### Re: Chelsea Gardens Estate

SEEC have been invited by Aoyuan International (our client) to respond to peer reviewed comment on SEEC report 2000035-LC by 03/05/2022 to align with a scheduled meeting between the client and Wingecarribee Shire Council. The report in question has multiple revisions it is assumed the comments made relate to the latest revision 20000305-LC-03 dated 6/11/2020. Comments made by the peer reviewer and SEECs response are presented below:

Copy of Figure 2 from Harvest Report 2006.

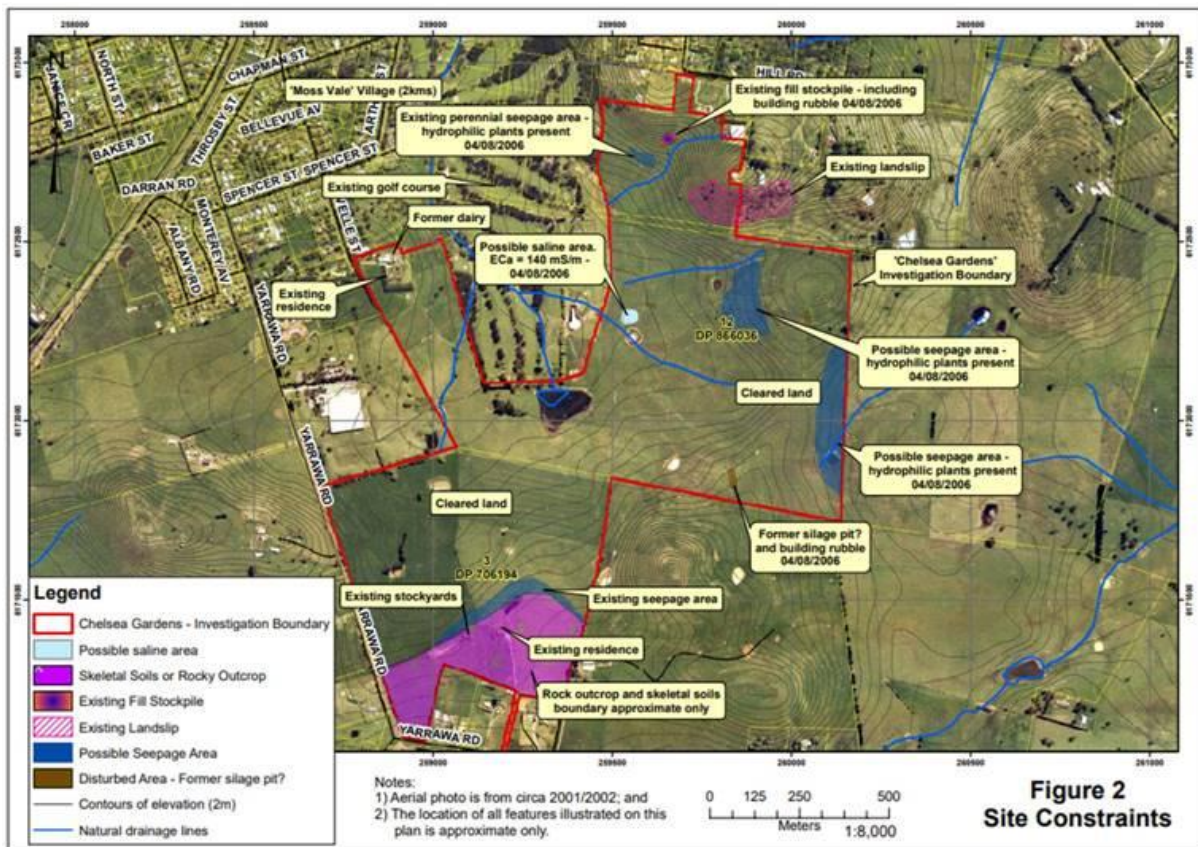
“...the LCA outcomes for site hydrology and groundwater do not align with the previously completed Capability Assessment by Harvest Scientific Services (2006) which identified high groundwater value and the presence of both intermittent and perennial seeps. Two intermittent seeps were identified by Harvest within and immediately downslope of the proposed irrigation areas.”

At Page 7, an area of seepage is reported as having been observed around the rock outcrop on the south-east portion of the site (currently planned for Stage 2). This area is identified in Figure 2 as being around the perimeter of the purple-coloured rock area and is distant from the proposed irrigation area in the east of the site.

Further, an existing perennial seepage area is noted as having been observed in the northern portion of the site. This area is located to the north of Shelly Road in Figure 2 and again distant from the proposed irrigation area.

At page 7, of the Harvest Report there is a comment that “rush plant species (*Juncus* sp) were observed sporadically over the major part of this site. This plant species indicates that the site is probably poorly drained (in places) and possibly intermittently saturates.” There are two areas in Figure 2 which are adjacent to the proposed irrigation area where these plants were observed. It is noted that these areas are not identified as seepage areas, just areas with rush plants.

At page 20, the Harvest Report confirms that “During field investigations on the 4th of August, 2006, two main areas of seepage were observed on this property (Figure 2). The first

of these was located in the northern portion of the CGDS in the steep area near hill road and the second occurs in the southern portion of this CGDS at the base of the syenite/microsyenite plateau." Both of these areas are identified in Figure 2 and are both distant from the proposed irrigation zone.

It is noted that SEEC Test pits 2 and 5 are located in the eastern blue area marked in the Harvest Figure 2 as a "possible seepage area" and that SEEC Test pits 4 and 7 are in the

*other blue area marked in the Harvest Figure 2 as "possible seepage area" located to the immediate west of the proposed irrigation area.*

*These SEEC test pits were excavated to a depth of at least 1m and no sign of saturation or seepage was noted. The soils were generally classified as being "moderately well drained".*

*In conclusion, I have reviewed the 2006 Harvest Scientific Services report and the SEEC land Capability Assessment against the comments in the DWA Peer Review and cannot find any evidence to support the findings of the peer review. The Peer Review states that the Harvest Report found high ground water values but there are no such references in the Harvest Report in the area of the proposed irrigation area. The Peer review infers that the Harvest Report found perennial and intermittent groundwater seeps in the vicinity of the proposed irrigation area but the only seepage areas identified in the Harvest Report are located well to the north and south of the proposed Irrigation area which will not be impacted upon or impact on the proposed irrigation area. The Peer Review states that "Two intermittent seeps were identified by Harvest within and immediately downslope of the proposed irrigation areas." This is factually incorrect. The two areas immediately downslope of the proposed irrigation area were identified in the Harvest Report as "possible seepage areas" based on the vegetation observed on site only. Subsequent test pit data obtained by SEEC did not identify any saturation issues with the soils in these areas."*
